Product Change Notification / LIAL-14RZLJ133

CCB 4159 Final Notice: Implement Microchip Part Aging Policy, Recertification and Combination rules, Labels and Packing Changes for selected Microsemi Field Programmable Gate Array (FPGA) and Mixed Signal and ASIC(MSA) products

CCB 4159
Pre and Post Change Summary
PCN#: LIAL-14RZLJ133

Labels change

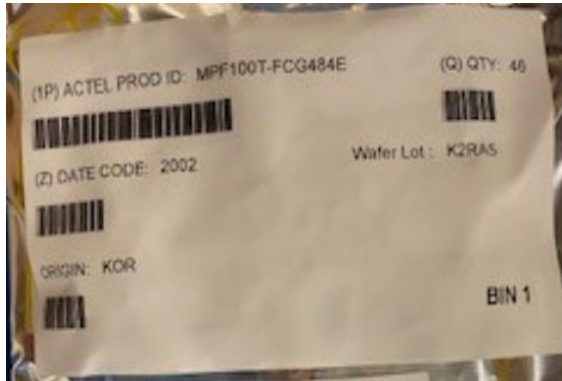
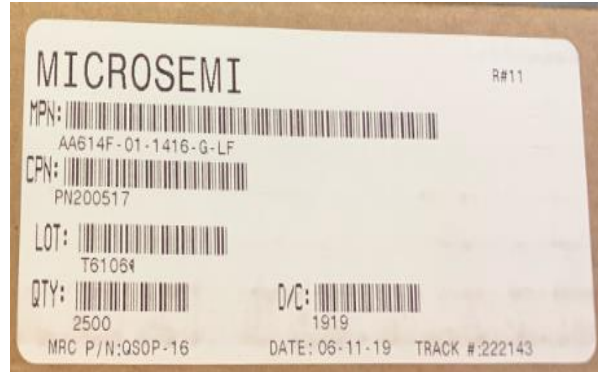
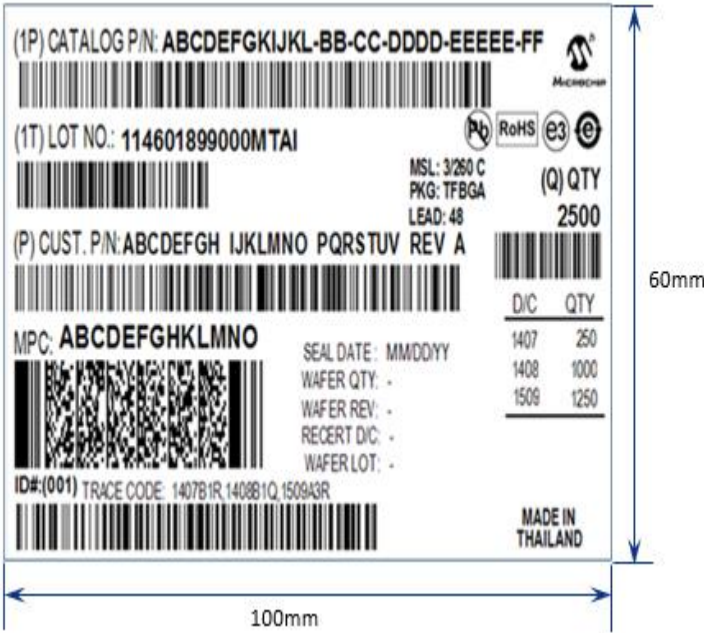
- **Reel/Bag/Inner Carton Label:** Change to Microchip standard inner label
- **Outer Carton Label:** Change to Microchip standard outer carton label
- **Device Code label:** Change company name to Microchip
- **MSL Caution label:** Change label template to Microchip standard
- **ESD Warning label on MBB:** Affix ESD Warning Label on the MBB for class zero product only. For others device refer the ESD caution symbol that pre-printed on the MBB.
- **Inner Carton ESD Sealing Label:** Remove ESD Sealing label
- **MSID Label:** Affix MSID label or pre-printed MSID symbol on the inner carton for moisture sensitive devices.

Class Zero

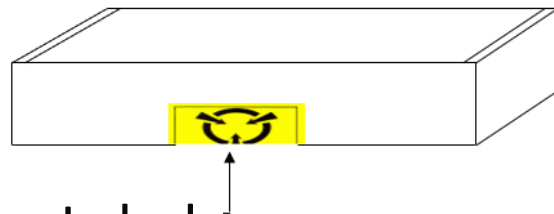
Affix ESD Warning Label on the MBB for class zero product only. For others device refer the ESD caution symbol that pre-printed on the MBB.

Moisture Sensitivity Identification label (MSID Label)

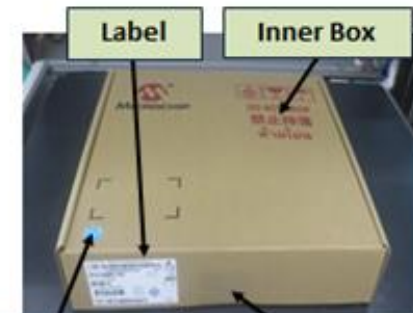
Not apply MSID label on the inner carton.

44L PLCC Tube Drawing

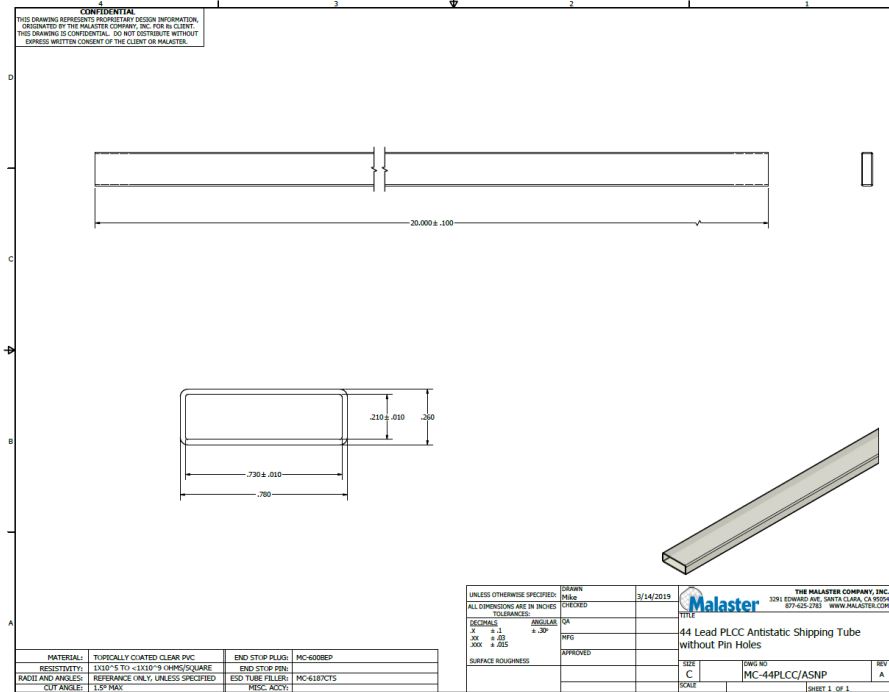
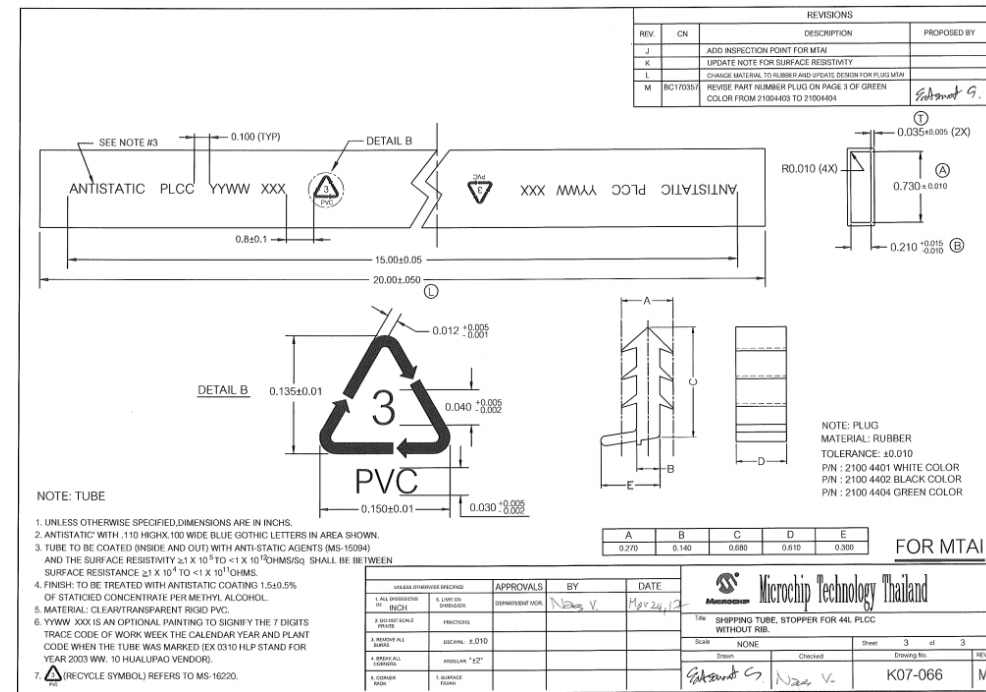
LOCATION	Length (in)	A (in)	B (in)	Thickness (in)	Tube Color	Units/Tube
FPGA	20.00 +/-0.100	0.210 +/-0.010	0.730 +/- 0.010	0.025	Clear	27
MTAI	20.00 +/-0.050	0.210 +0.015/-0.010	0.730 +/-0.010	0.035	Clear	27

68L PLCC Tube Drawing

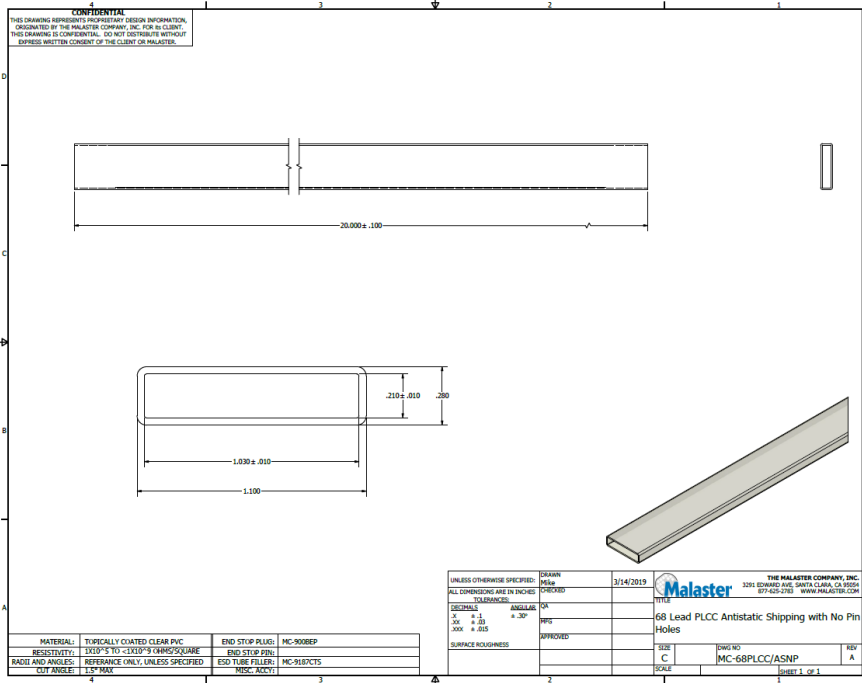
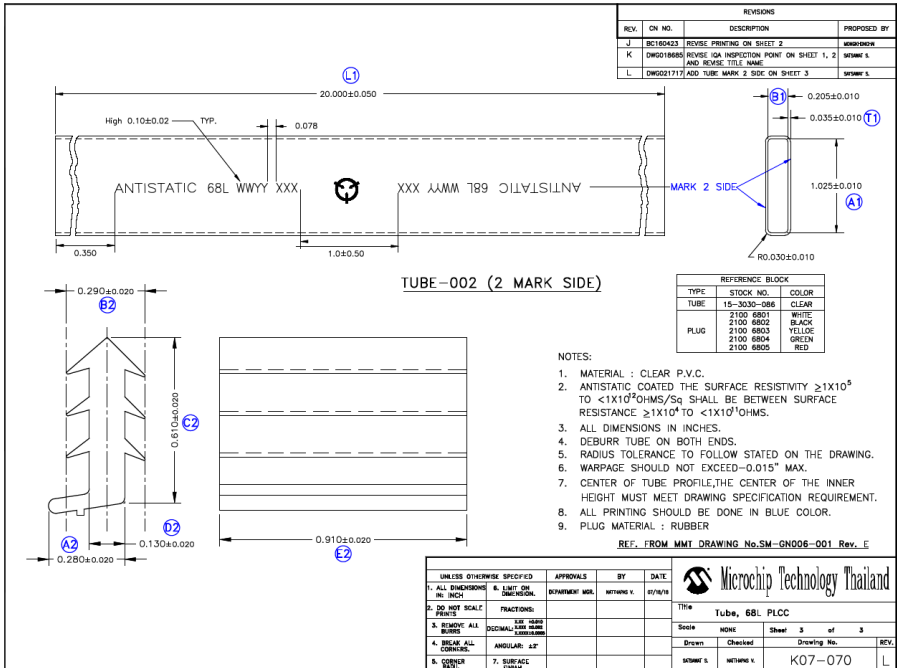
LOCATION	Length (in)	A (in)	B (in)	Thickness (in)	Tube Color	Units/Tube
FPGA	20.00 +/-0.100	0.210 +/-0.010	1.030 +/-0.010	0.035	Clear	19
MTAI	20.00 +/-0.050	0.205 +/-0.010	1.025 +/-0.010	0.035	Clear	19

84L PLCC Tube Drawing

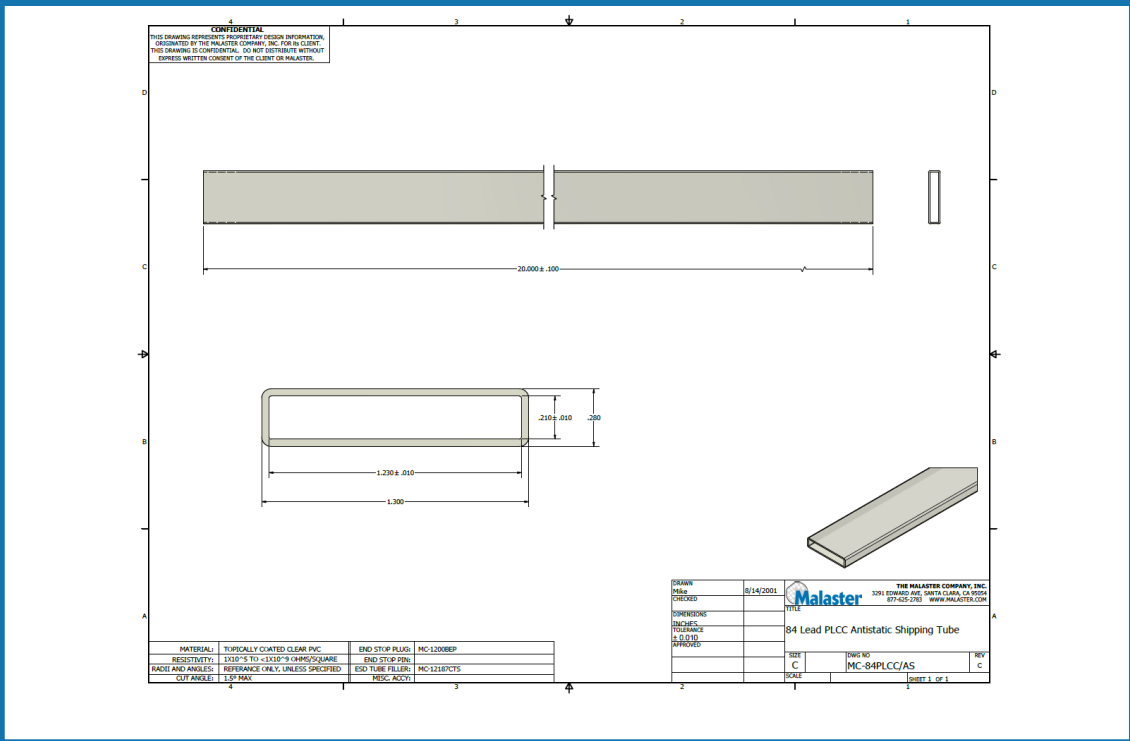
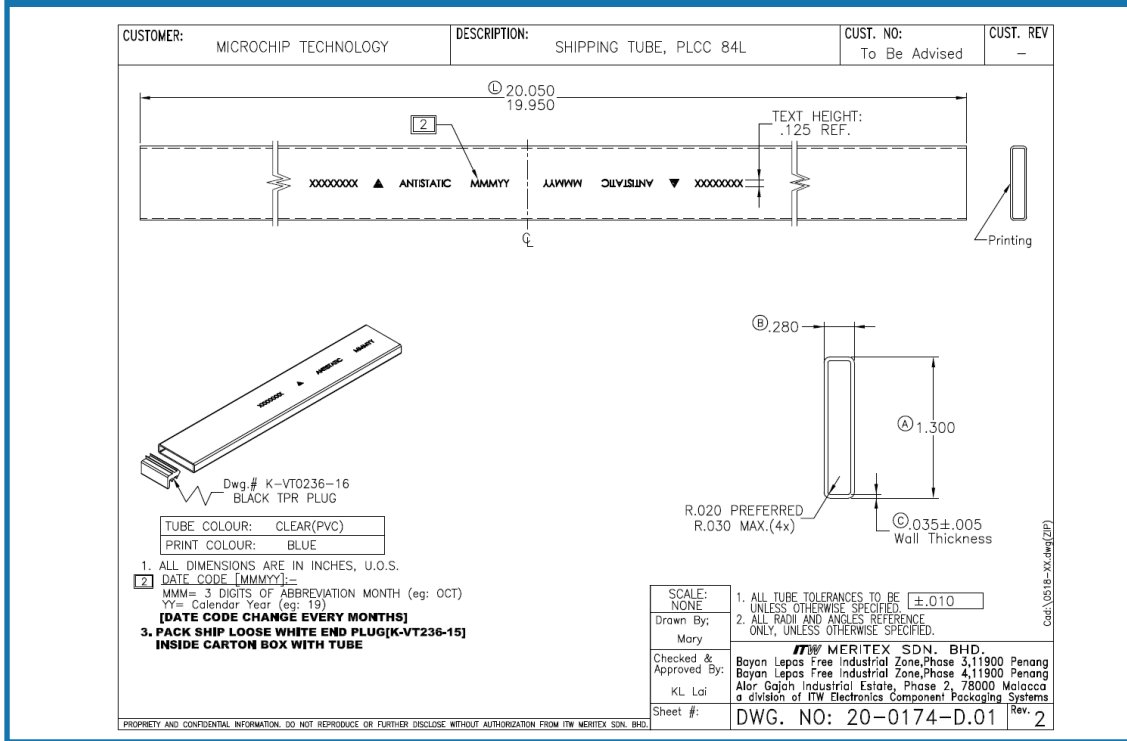
LOCATION	Length (in)	A (in)	B (in)	Thickness (in)	Tube Color	Units/Tube
FPGA	20.00 +/-0.100	0.210 +/-0.010	1.230 +/-0.010	0.035	Clear	16
MTAI	20.00 +/-0.050	0.210 +/- 0.010	1.230 +/-0.010	0.035	Clear	16

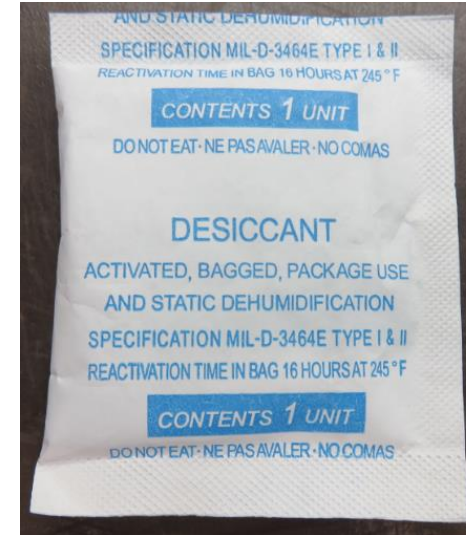
Packing Media	Amount of Desiccant per one MBB
Tray	2 Units (2 Units x 1 pouch)
Tube	2 Units (2 Units x 1 pouch)
13" TnR	2 Units (2 Units x 1 pouch)

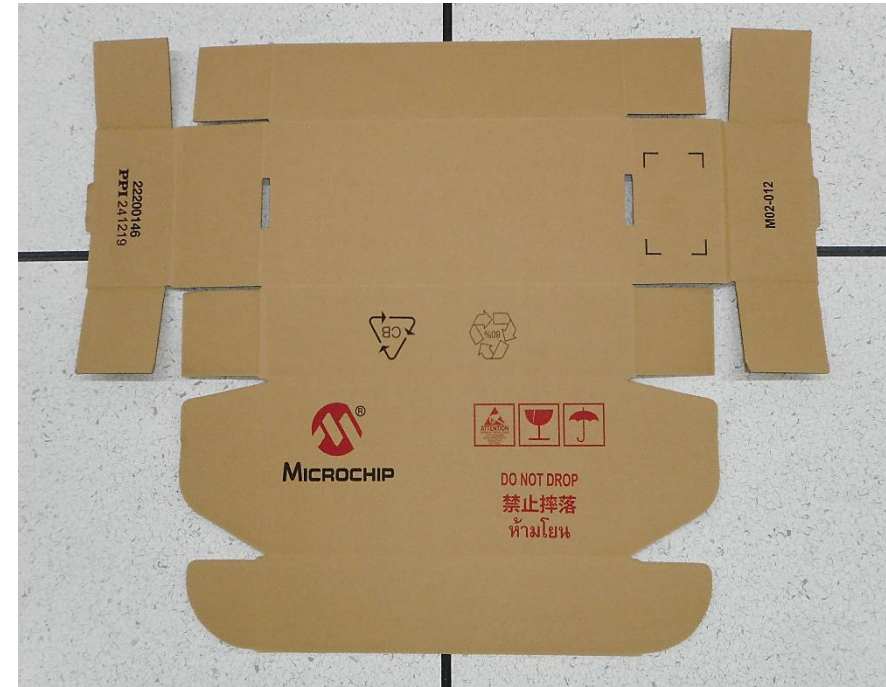
Drawing Number	Dimension (Cm)
QFPI	16.83 x 35.9 x 9.53

Drawing Number	Dimension (Cm)
M02-012	16.2x37.1x8.8

Tray Strapping Method

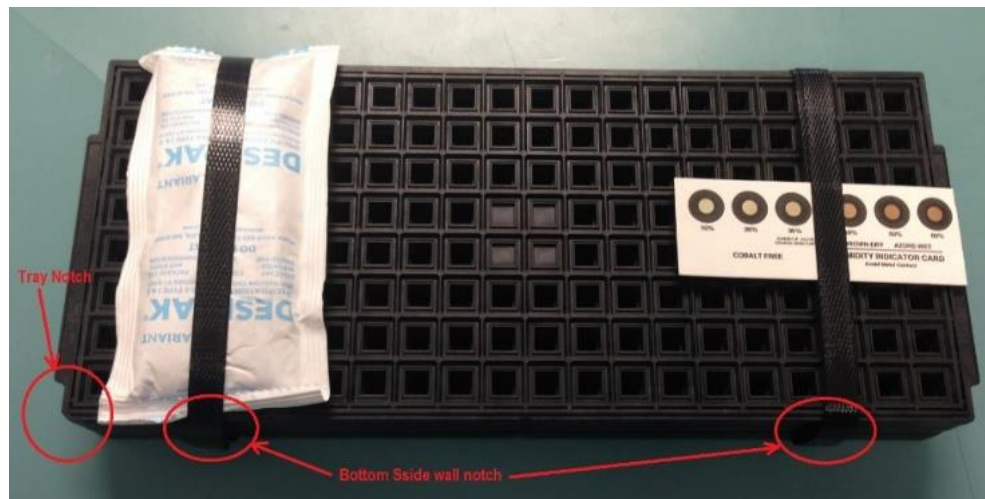
2 width tray strapping

Plug Color

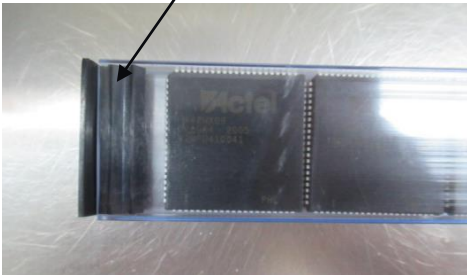
Using Black Plug for both sides
